2401 INTER COVER SHEET

2401 INTER AVE SE
PUYALLUP, WA 98372

DESCRIPTION	DATE	NUM	SCALE
INITIAL RELEASE	01/24/25	V1	1"=30'
SECOND RELEASE	06/23/25	V2	
DESIGNED			
W. MCINNIS			
DRAWN			
W. MCINNIS			
CHECKED			
J. MCINNIS			
DATE			
8/5/2025			
APPROVED			
J. MCINNIS			
JOB NO.			
24-166			
SHEET			
C1 OF C13			
C1

2401 INTER GRADING, DRAINAGE, AND UTILITY PLAN

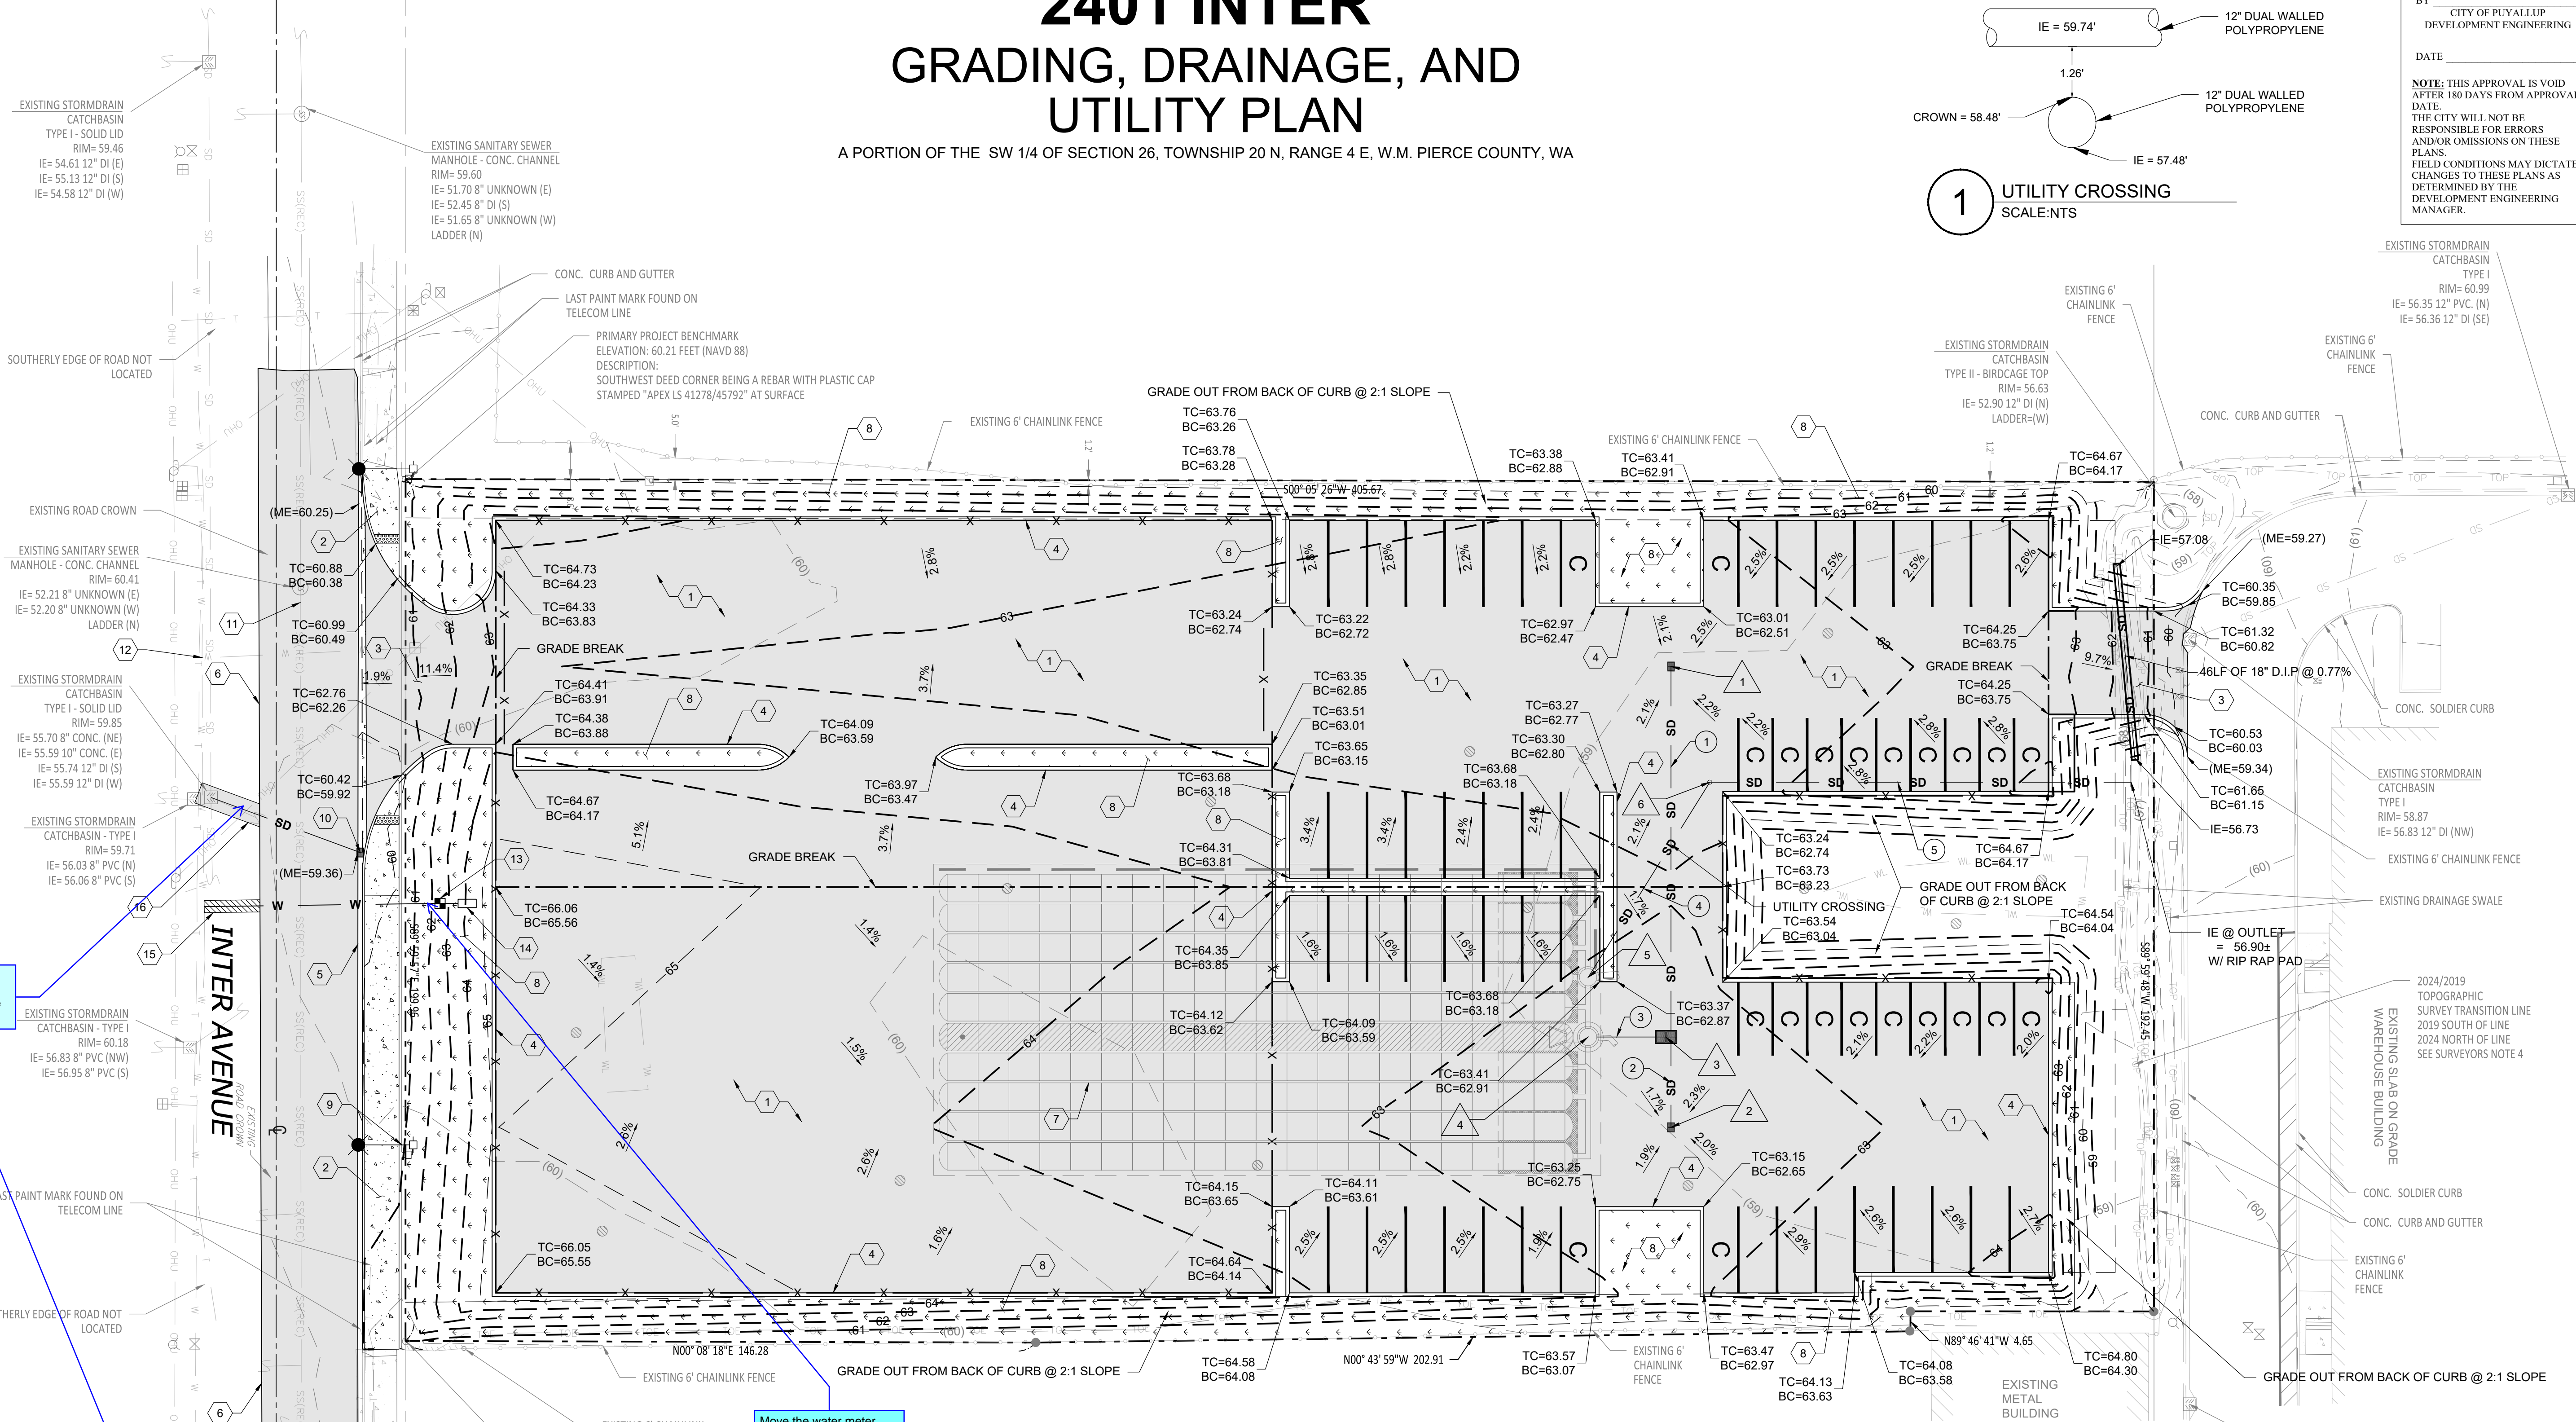
Move the water meter
flush up against the back
of the sidewalk

| 12 | REMOVE THE CORPORATION STOP ON THE WATER

2401 INTER STREET LIGHTING PLAN

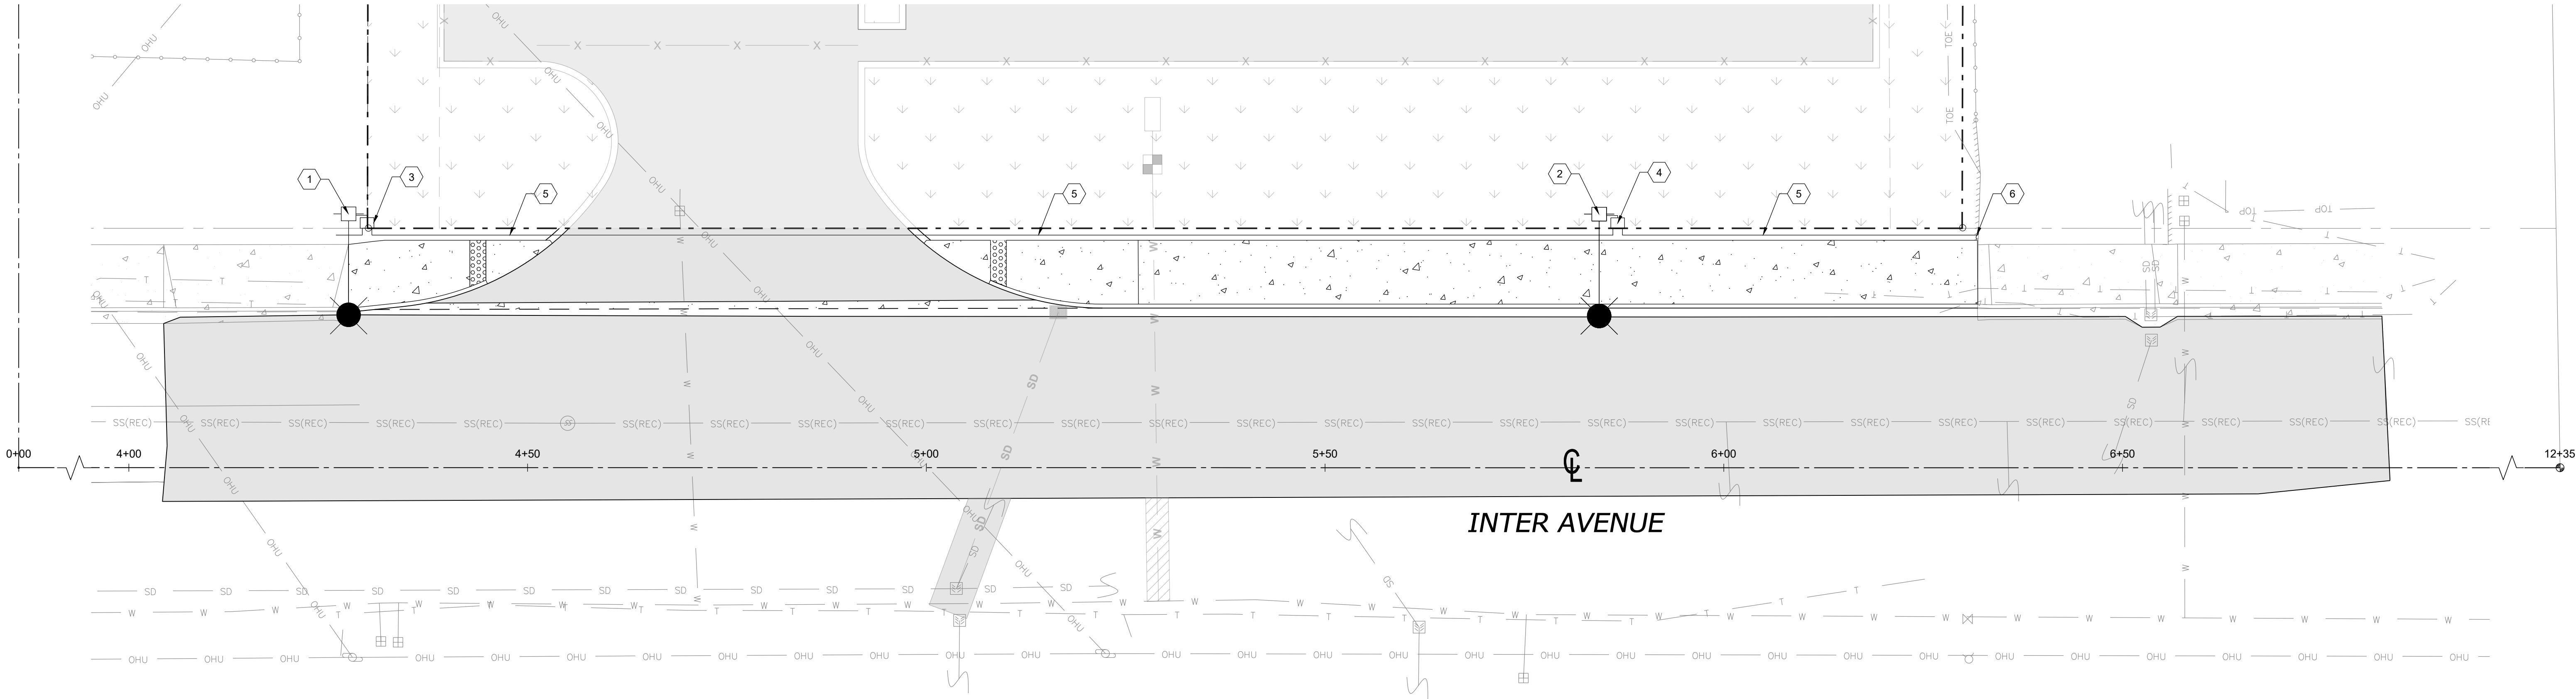
Revise note to say that connection is to be made at new J Box at the west property line of the neighbor to the east. Project needs to confirm proper wire size and voltage for this length of run. City can provide details of recent installation.
